# REQUEST FOR COUNCIL ACTION

AGENDA SECTION: PUBLIC HEARING	ORIGINATING DEPT: PLANNING	ITEM NO. <b>E-5</b>
ITEM DESCRIPTION: Final Plat #03-20 to be known as Northview Third Subdivision by HCS, LLC. The applicant is proposing to re-subdivide Lot 5, Block 1, Northview First Subdivision into 2 lots for development. The property is located along the east side of West Circle Drive, along the west side of 40 <sup>th</sup> Avenue NW and north of Valleyhigh Road NW.		PREPARED BY: Theresa Fogarty, Planner

**RE: Final Plat #03-20 to be known as Northview Third Subdivision by HCS, LLC. The applicant is proposing to re-subdivide Lot 5, Block 1, Northview First Subdivision into 2 lots for development. The property is located along the east side of West Circle Drive, along the west side of 40<sup>th</sup> Avenue NW and north of Valleyhigh Road NW.**

# NORTHVIEW THIRD SUBDIVISION

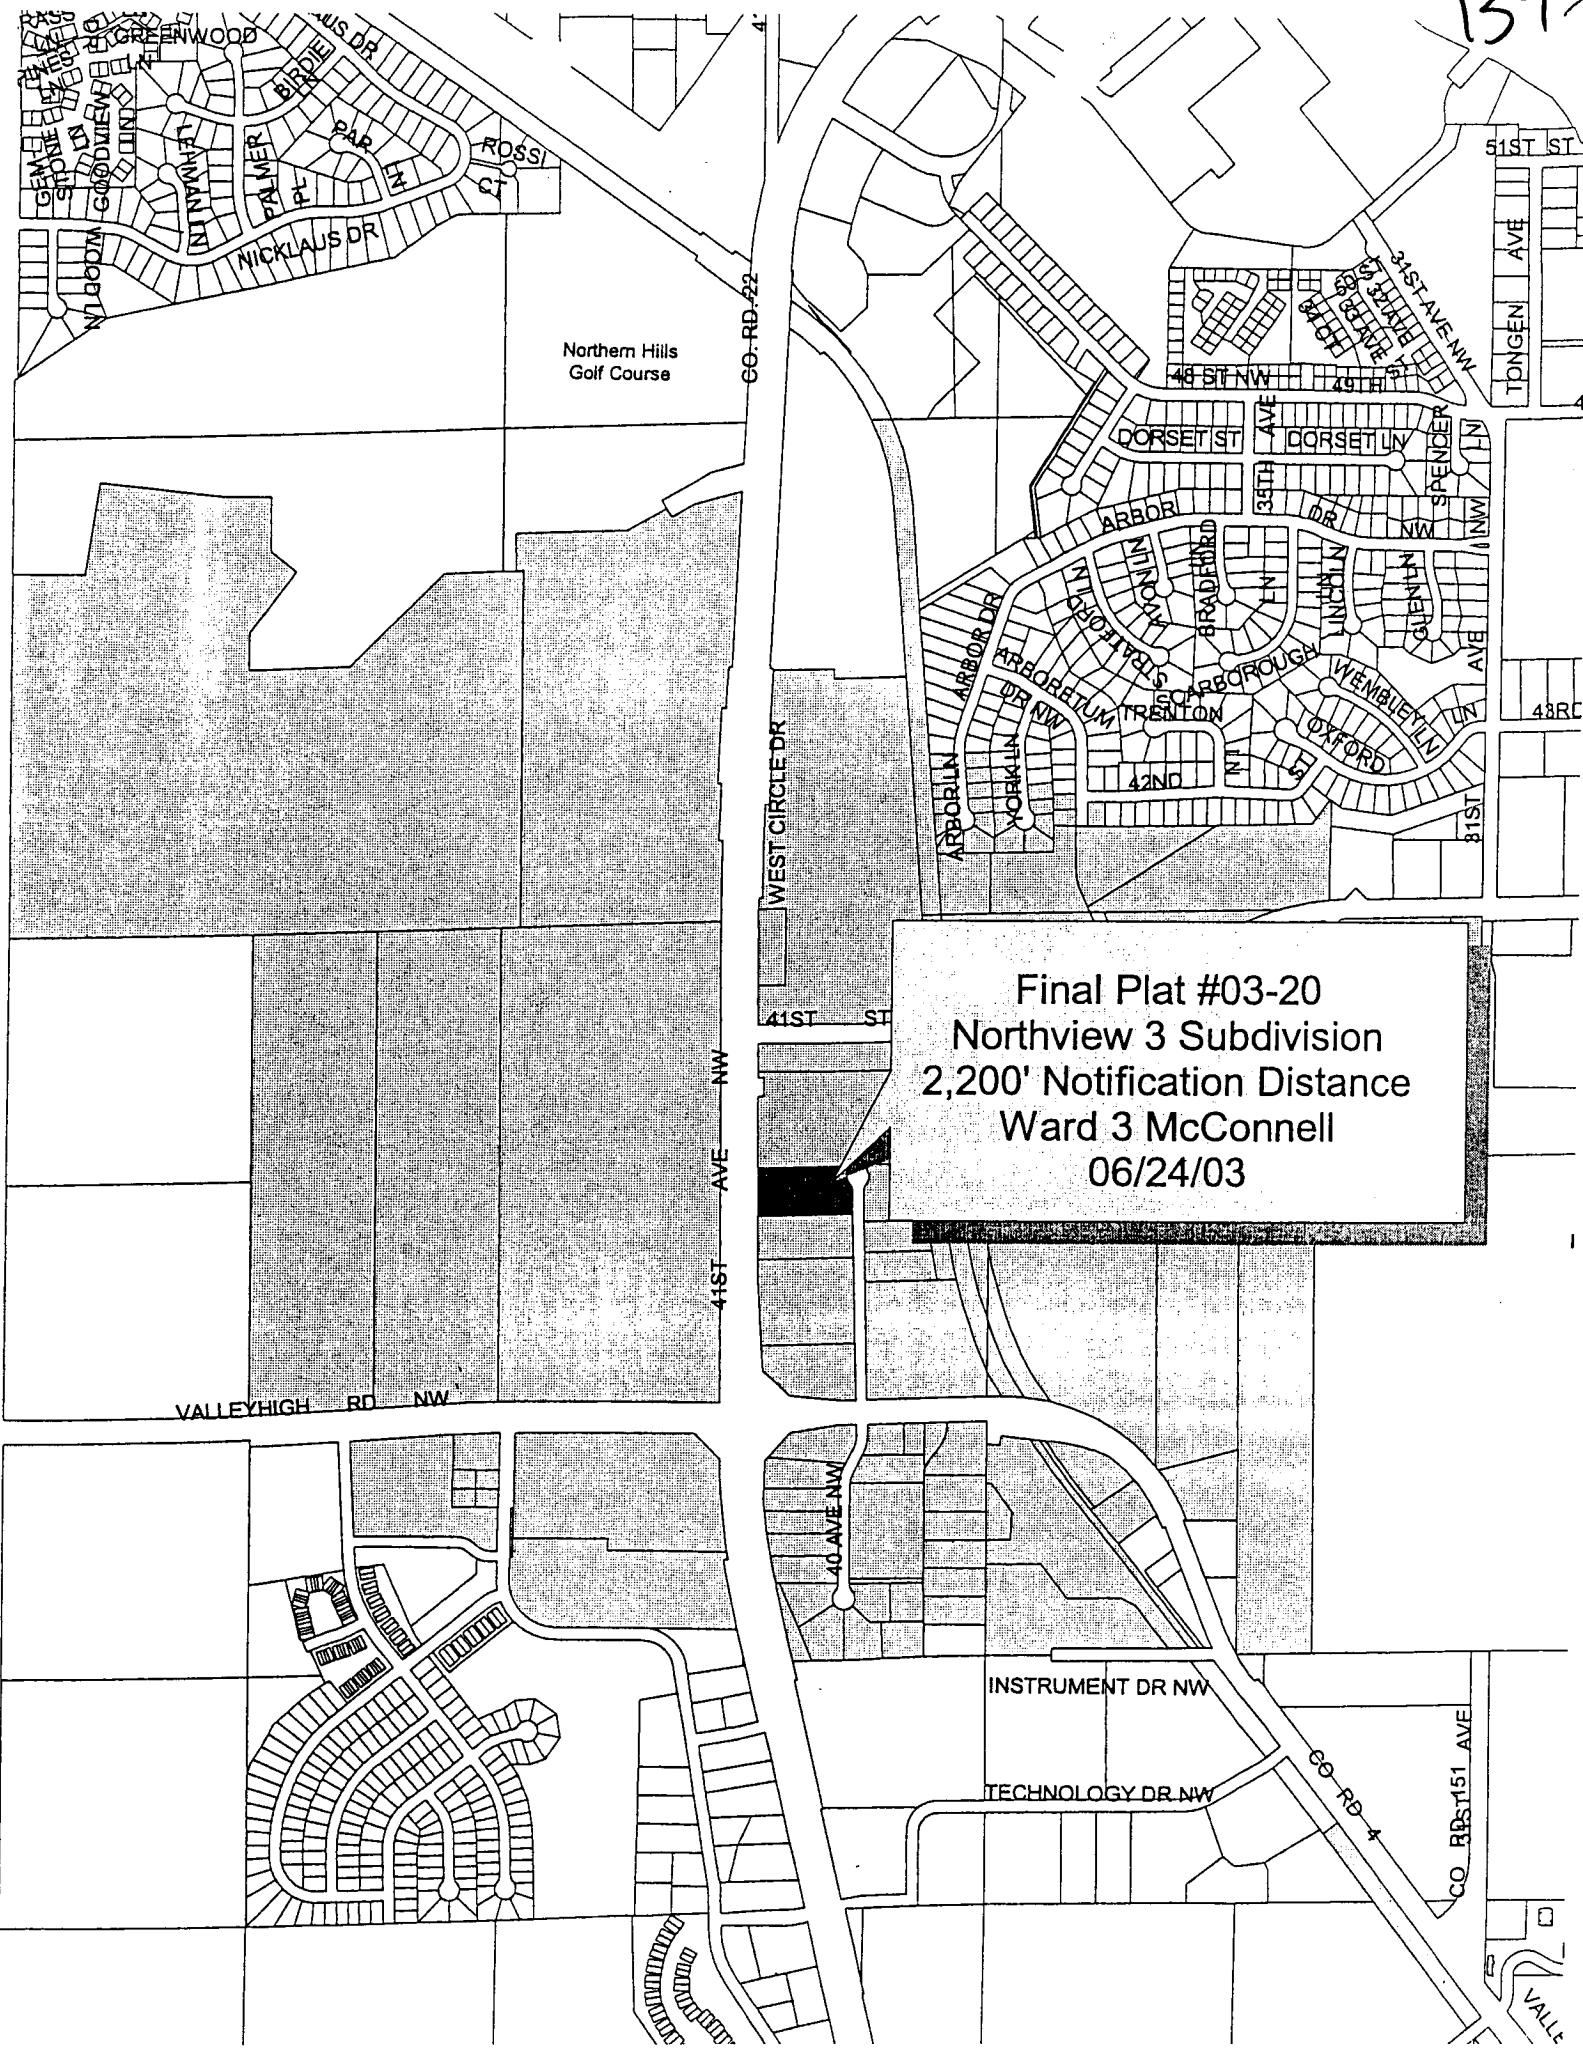
- 1. Prior to recording, the final plat shall be revised, as follows:**
  - a. Provide an additional utility easement providing water service to Lot 1, as requested by Rochester Public Utility Water Division Memorandum dated June 18, 2003 and Operations Division Memorandum dated June 24, 2003.**

- 3. Prior to recording the Final Plat, the owner/developer shall provide evidence of an access easement across proposed Lot 2, Block 1.**
- 4. Grading and Drainage Plan approval shall be required for individual lot development, and a Storm Water Management fee is applicable to any areas of impervious surface that do not drain to the existing privately constructed detention facilities serving the Northview Subdivision.**

- 5. The Owner/Developer shall construct a 10' wide bituminous pedestrian path along the entire frontage abutting West Circle Drive NW, concurrent with the development of Lot 1, Block 1.**

1. Since no access will be allowed from West Circle Dr NW to Lot 1, Block 1, evidence of an access easement across proposed Lot 2, Block 1 should be provided prior to Final Plat approval.

1. Additional public utility easements will be required to provide Lot 1 with water service.  
These must be dedicated prior to the development of these lots once the alignment is known.
